Subject: Invitation to Bid #1144-B Firing Range & Observation Tower

ADDENDUM # 1

ISSUE DATE: July 28, 2016
PROJECT TITLE: Fayette Co. Firing Range/Observation Tower
KAOD PROJECT #: 1464.00
INVITATION FOR BIDS#: 1144-B
RECIPIENTS: Owner

SK-1

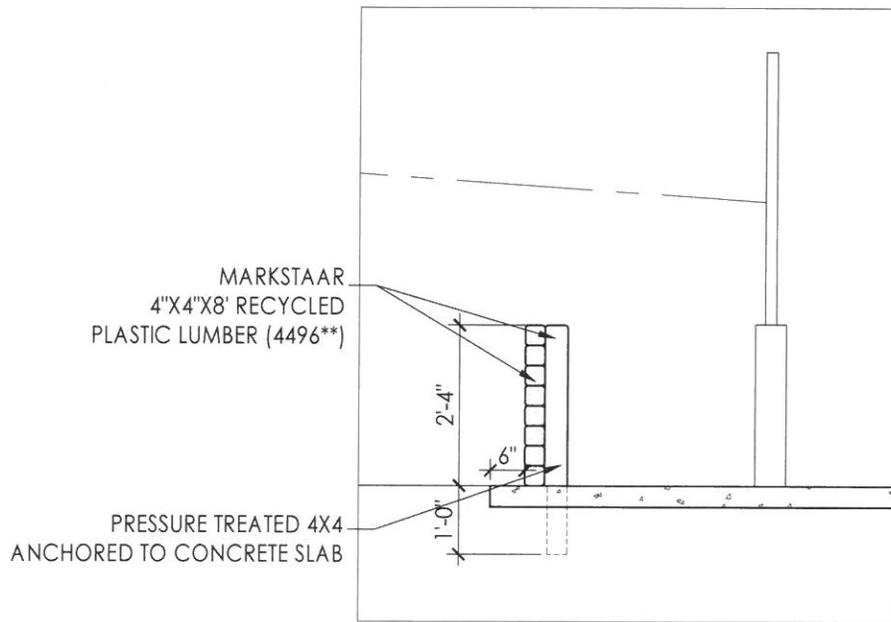
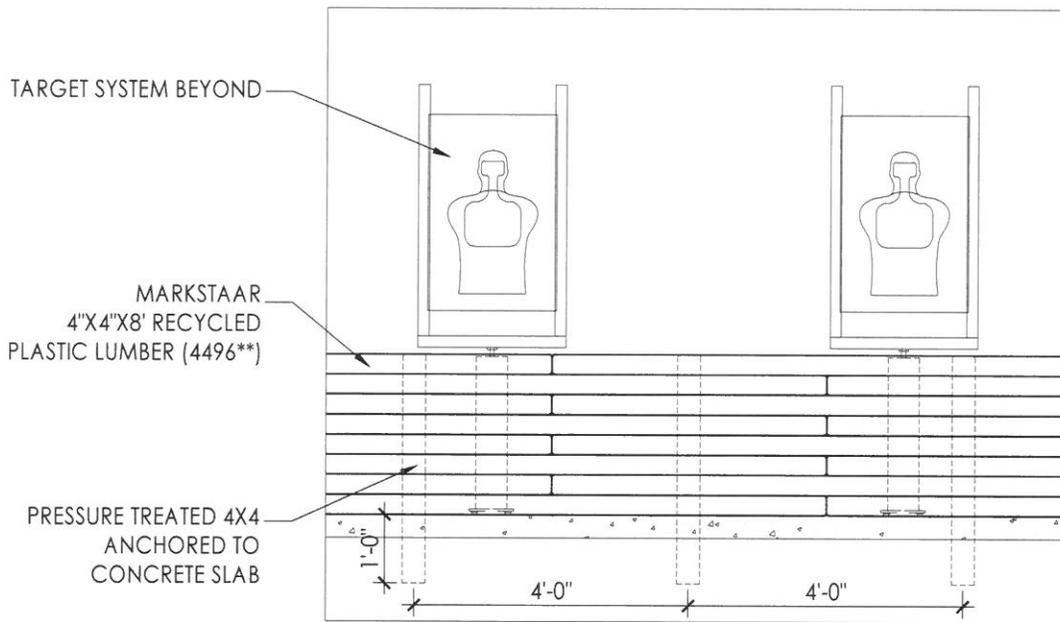
20. What is the knee wall details?

See SK-1

SK-2

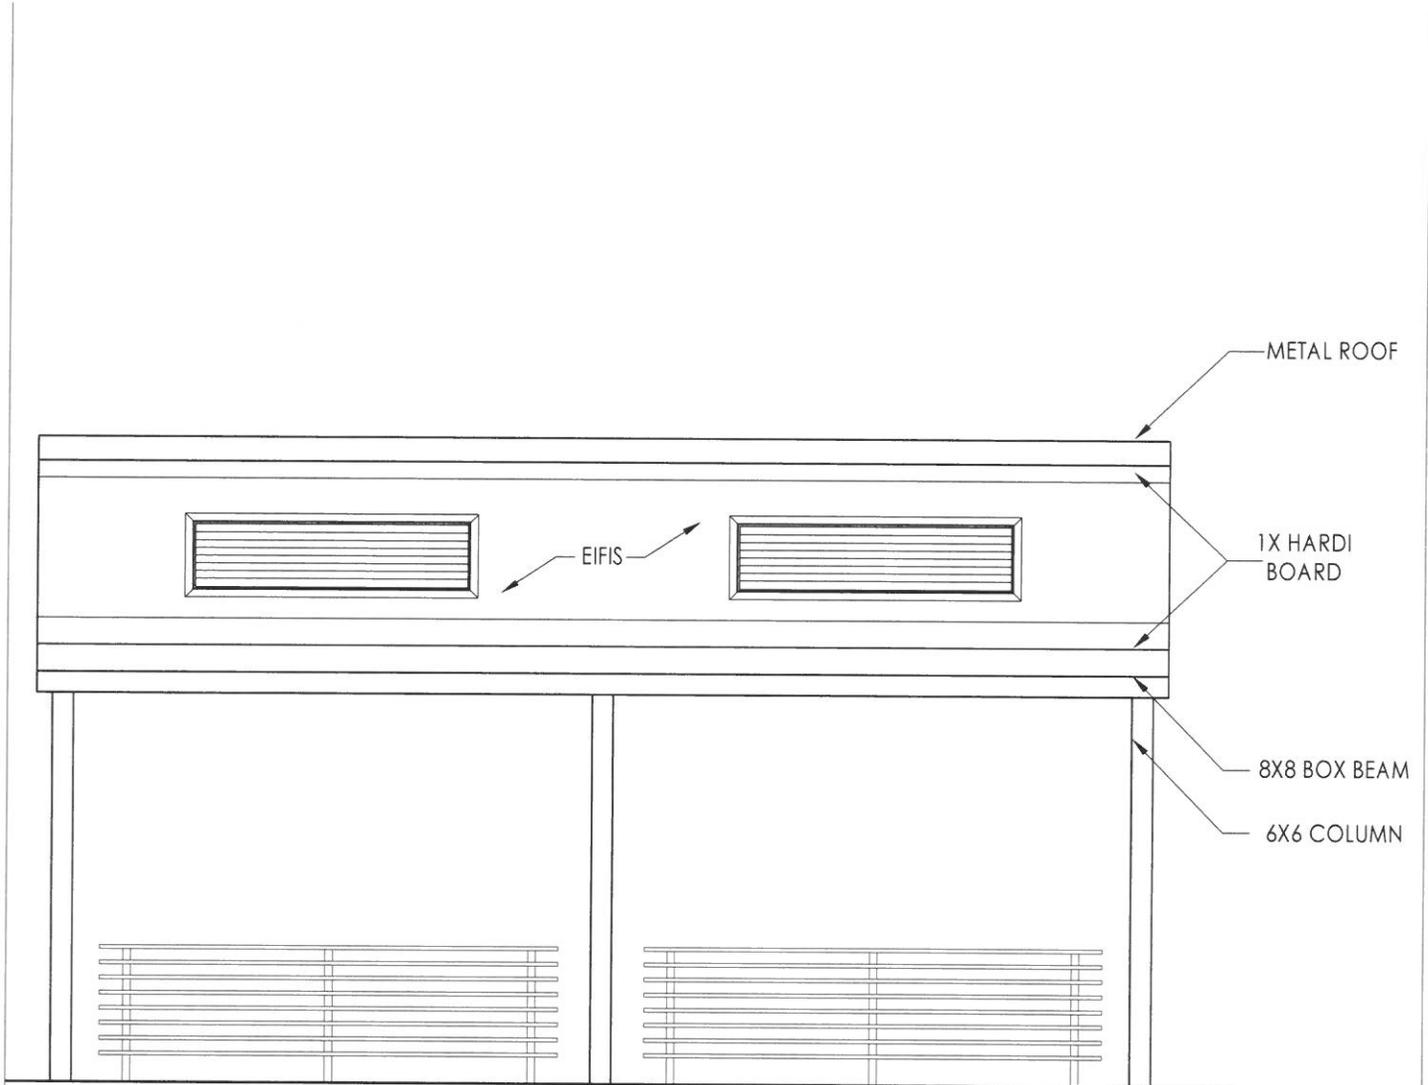
22. On Drawing A203, on the face of the pavilion with the two louvers, the note shows the face of that side of the pavilion to be "Metal Roof" - and the two sides of the pavilions are shown to get EIFS. It also references to Detail 1 on Drawing A302. On Drawing A302, it looks like the exterior wall with the two louvers gets Hardi Panels on the exterior. Please review and let us know which exterior finish will be required on the exterior walls of the pavilions.

The front elevation is EIFIS with 1x Hardi Board trim along the top and bottom face.

See SK-2

SK-3

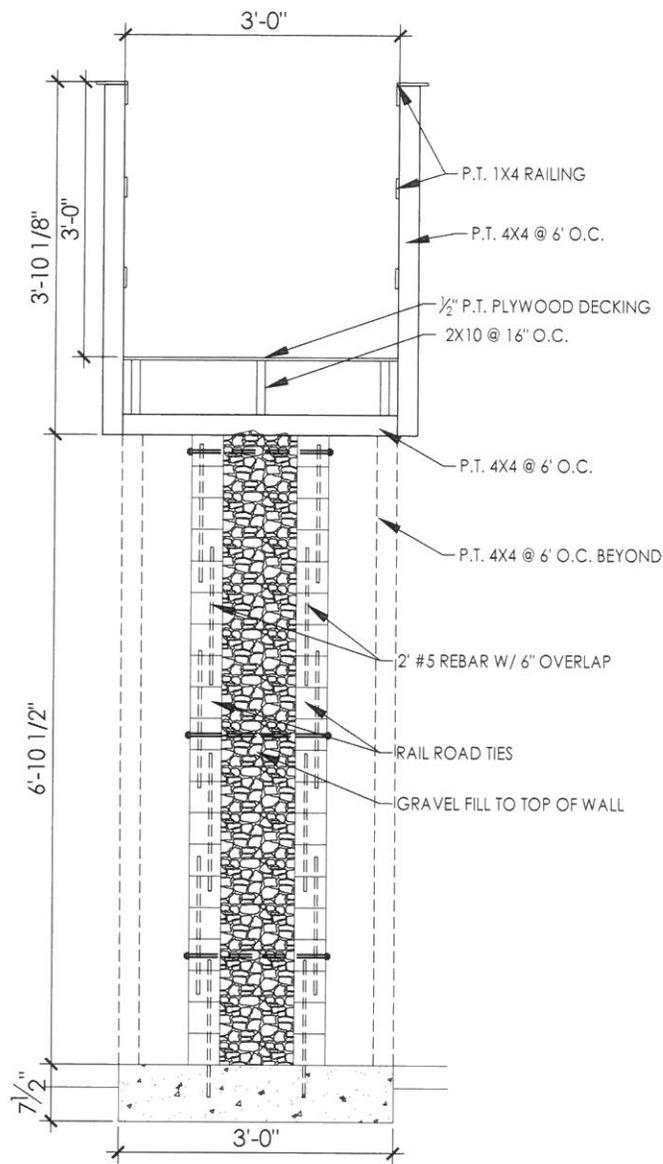
19. What is the perpendicular spacing on the 4x4 posts on the shoot house for the cat walk? it shows them on top of the RR tie wall but there's no detail on the spacing between them.

4x4's will be spaced 6' O.C.

See SK-3
